PROJECT NAME	HILO WWTP REHABILITATION & REPLACEMENT PROJECT PHASE 1	
PROJECT NUMBER	WW-4705R	
SUBMITTAL #	001.1	
SPECIFICATION SECTION	01500	
<b>SHOP DRAWING REVIEW</b>		
<b>ENGINEER'S REVIEW</b>		<b>CONTRACTOR'S ACTION</b>
<input checked="" type="checkbox"/> No Exceptions		Confirm
Make Corrections Noted		Resubmit
Rejected		
Comments Attached		
<p>Engineer's review is for general conformance with the design concept and the contract requirements. Markings or comments shall not be construed as relieving the Contractor from compliance with the project plans, specifications nor departure therefrom. The Contractor remains responsible for details and accuracy, for conforming and correlating all quantities and dimensions, for selecting fabrication processes, for techniques of assembly, and for performing his work in a safe manner.</p>		
<b>R.M. TOWILL CORPORATION</b>	Date	5/13/25
	By	 Michael S. Hong – Construction Manager

<b>Owner:</b>	County of Hawaii	<b>Date:</b>	5/7/2025
<b>Contractor:</b>	Nan, Inc.	<b>Project No.:</b>	WW-4705R
<b>Project Name:</b>	Hilo WWTP Phase 1	<b>Submittal Number:</b>	01500-001.1
<b>Submittal Title:</b>	Resubmittal -TEMPORARY FACILITIES & CONTROLS FIELD OFFICE

ENGINEER'S OFFICE TRAILER 1 - INTERIOR ELEVATIONS

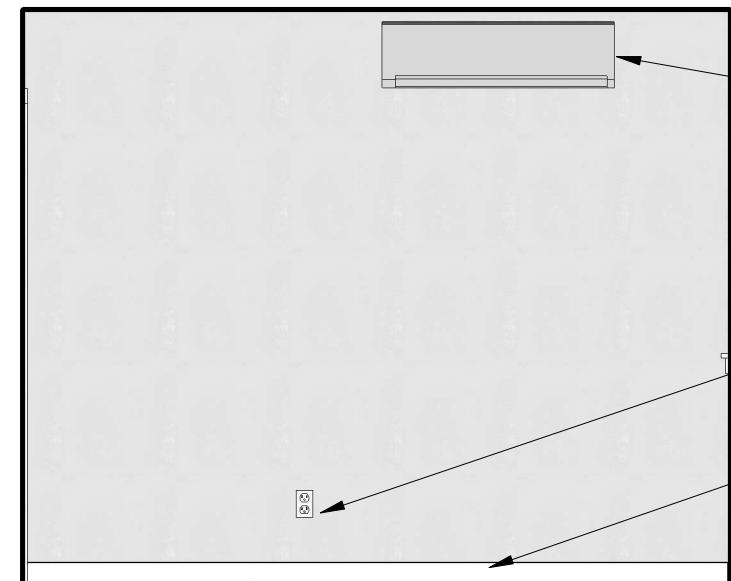
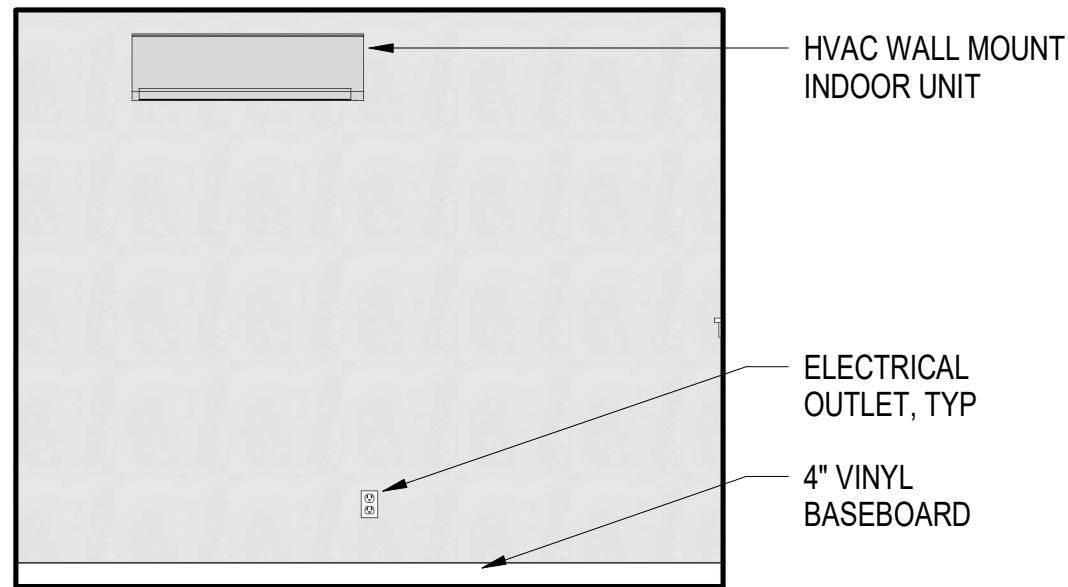
- Specification Section 01550 paragraph 1.12.7
      - b. Owner's Field Office:
        - 1) All windows shall have insect screens, locks, and blinds.

- Incorporated: See Dwgs A5.03
- Incorporated: See Dwgs A 1.07
- Incorporated: see dwgs A3.01
- Response: This submittal to be reviewed by owner. Does not to be displayed on dwgs. Contractor to provide per specifications

ENGINEER'S OFFICE TRAILER 2 PLAN

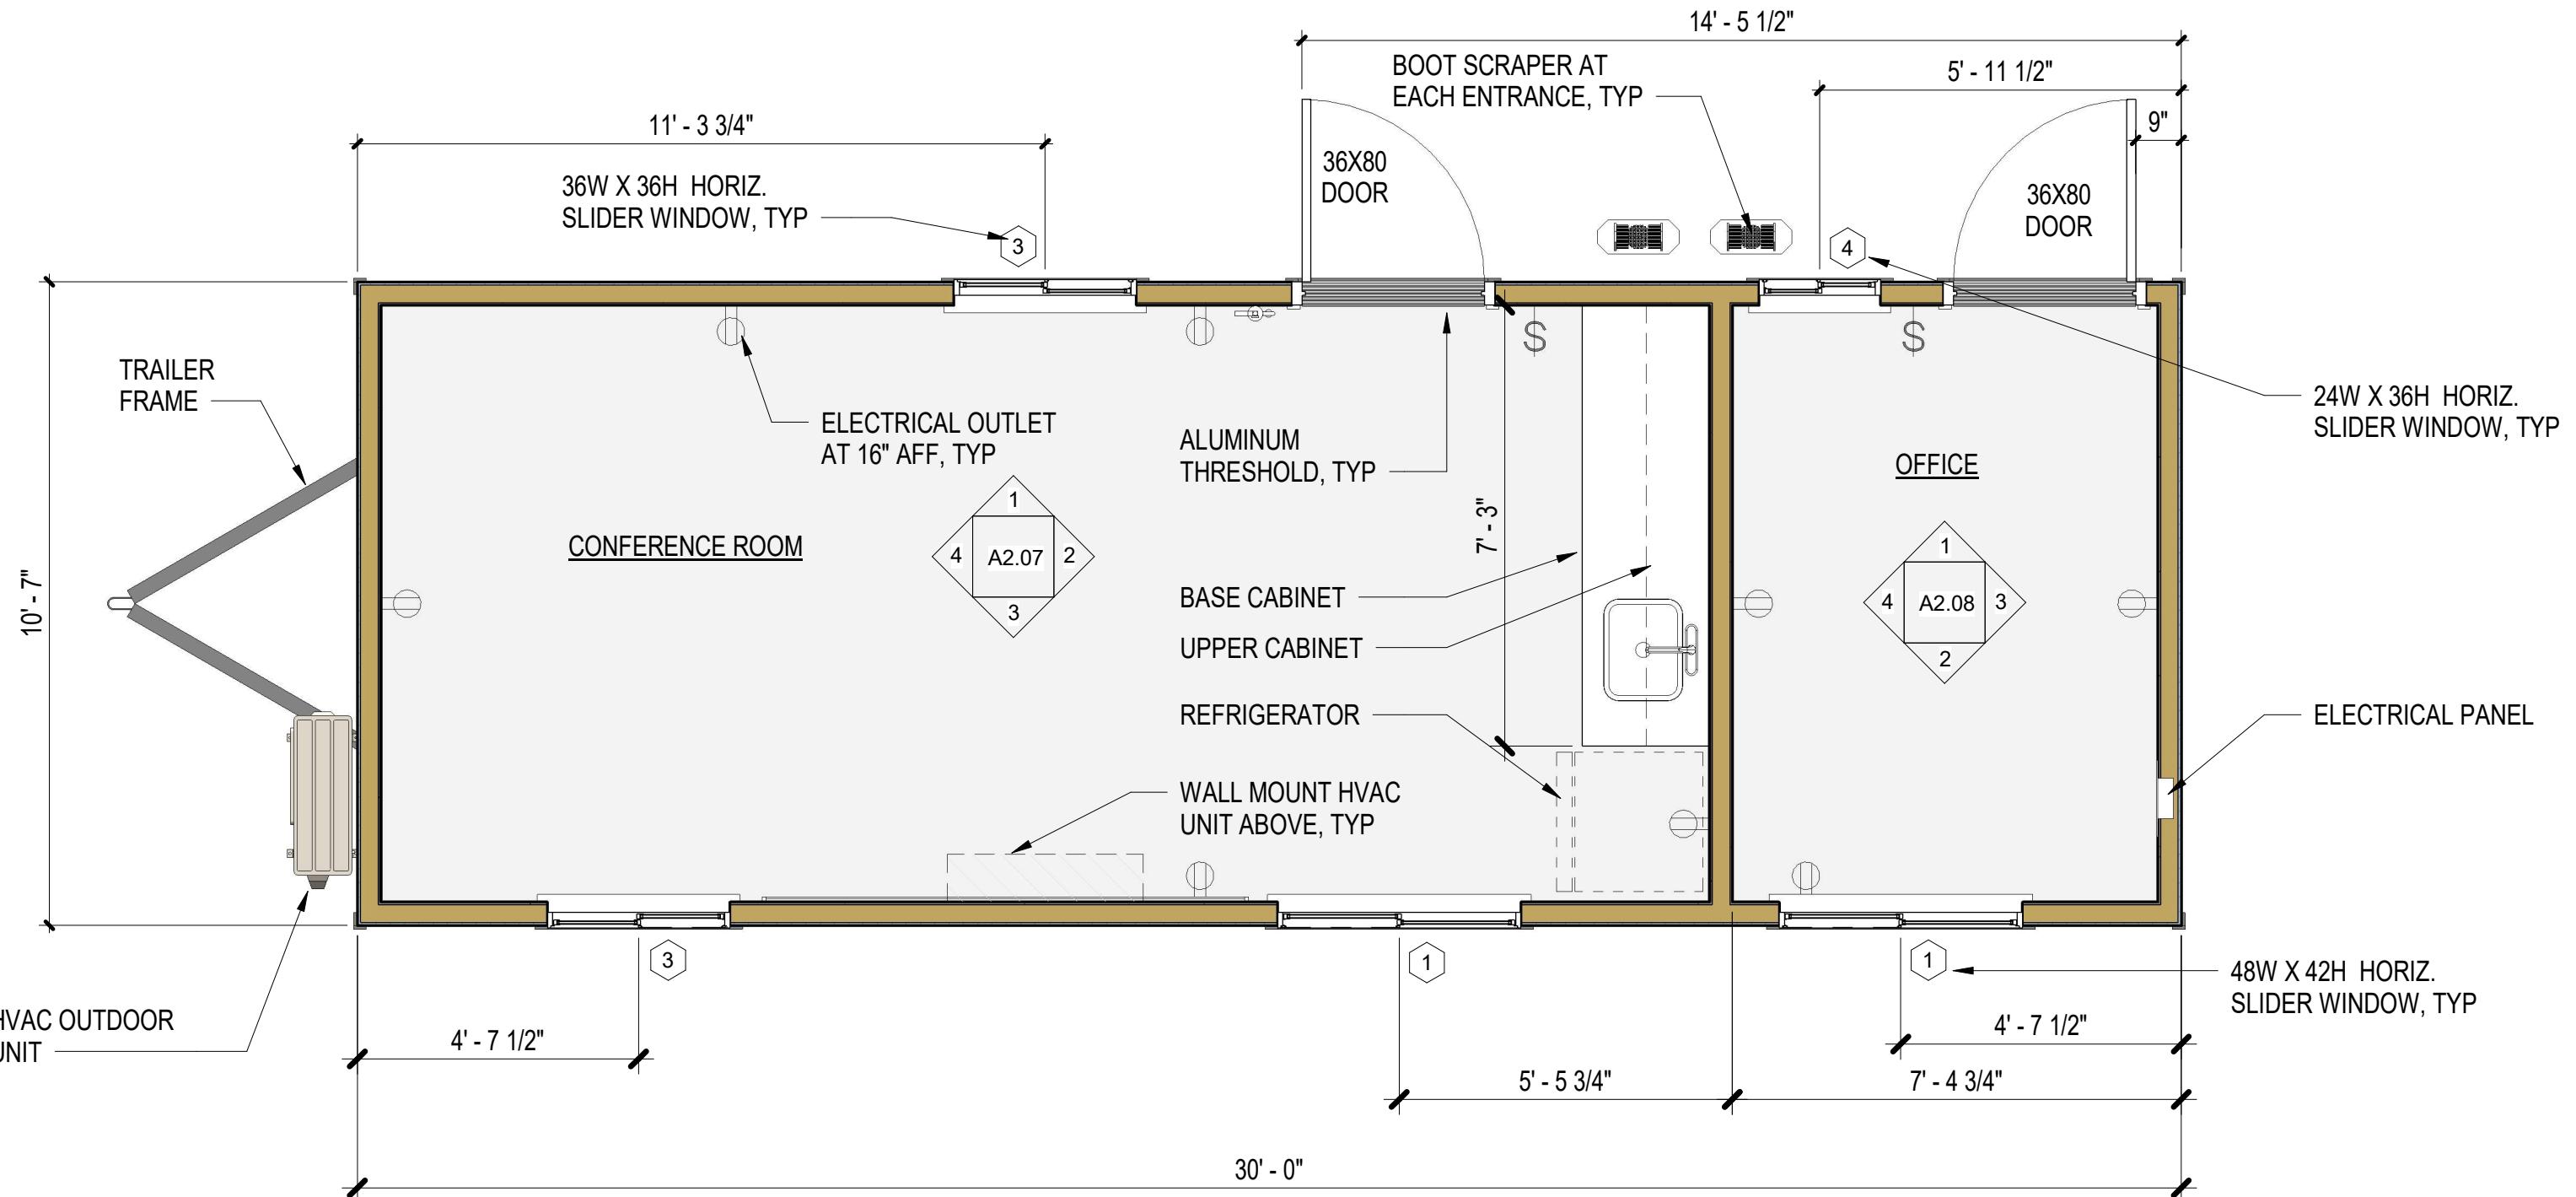
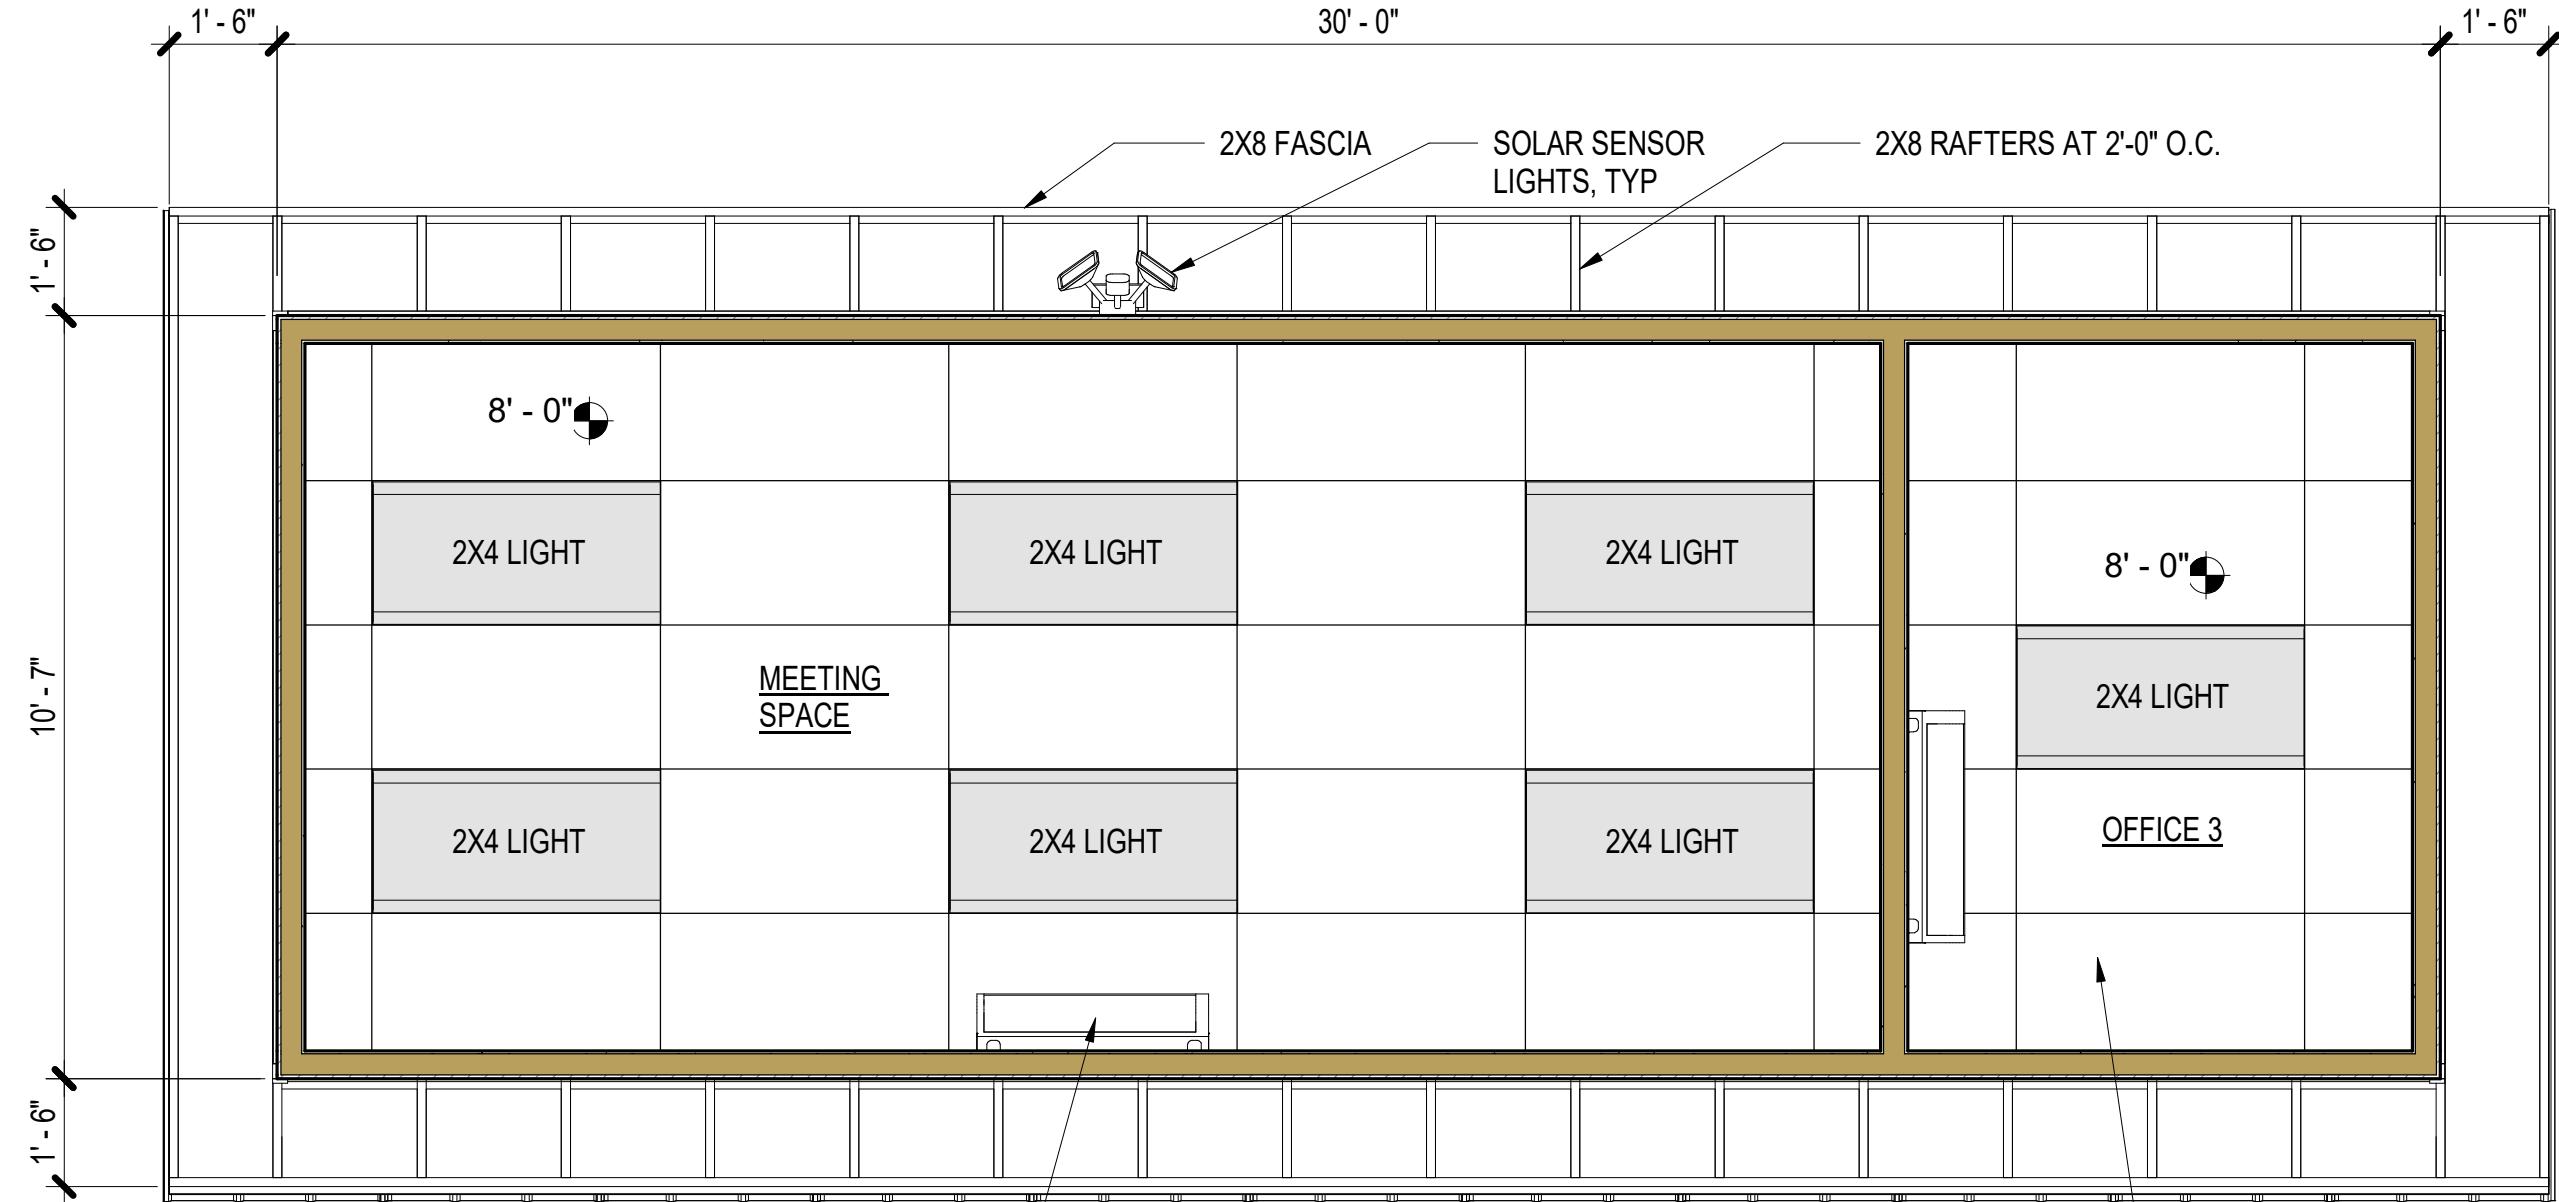
- Location of kitchen sink not provided in Owners Field Office and Engineer's Field Office 2
    - Incorporated: see dwgs A3.01, A2.01 respectively
  - Specification Section 01550 paragraph 1.12.B lists a number of items required for the field offices. Provide submittal information for the following items:
